DESIGN #	DRAWN BY EP	DART AEROSPACE LTD HAWKESBURY, ONTARIO, CANADA	
CHECKED #	APPROVED [Signature]	DRAWING NO. DEO 9157	REV. B SHEET 1 OF 1
DATE 99.10.21		TITLE DIMENSION CHANGE	SCALE NTS
A	99.07.12	NEW ISSUE (TSR A1227)	
B	99.10.21	CORRECT ERROR (0.500 WAS 0.625)

DART ENGINEERING ORDER

TO AMEND DRAWING D2750 REV. C

D2750-1/+3 LH SKIDTUBE SHOWN
D2750-2/-4 RH SKIDTUBE OPPOSITE

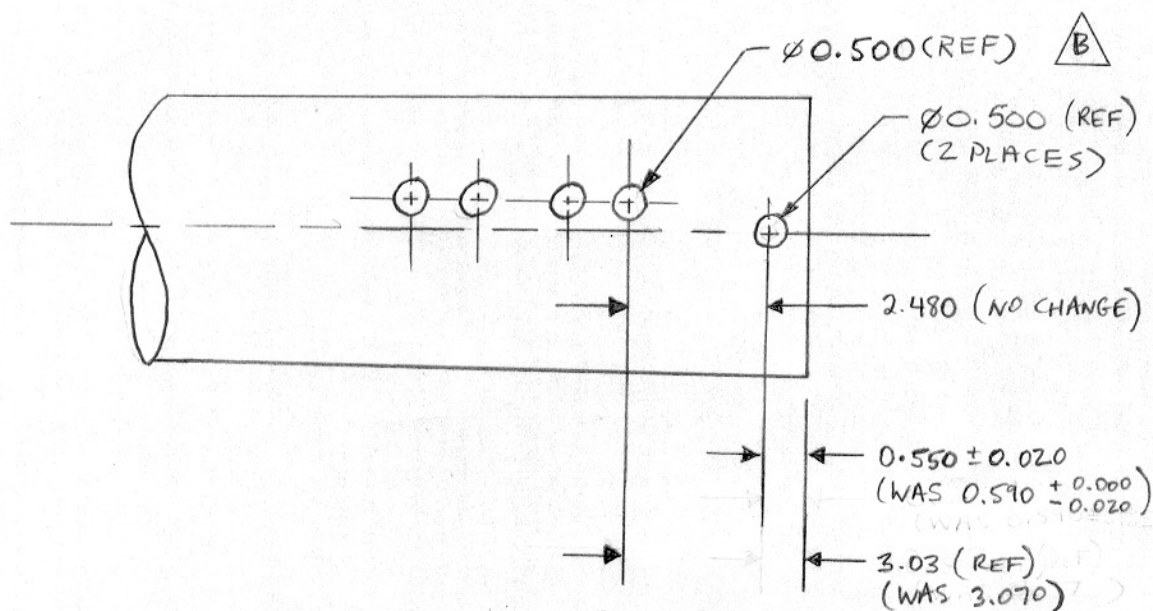
Ø0.500 HOLES SHOWN ON PAGE 3 SHOULD BE LOCATED
 0.550 ± 0.020 FROM AFT END OF SKIDTUBE INSTEAD OF
 0.590 ± 0.000 (2 PLACES).

NOTE: OVERALL LENGTH OF TUBE IS NOW 112.48 (WAS 112.52)
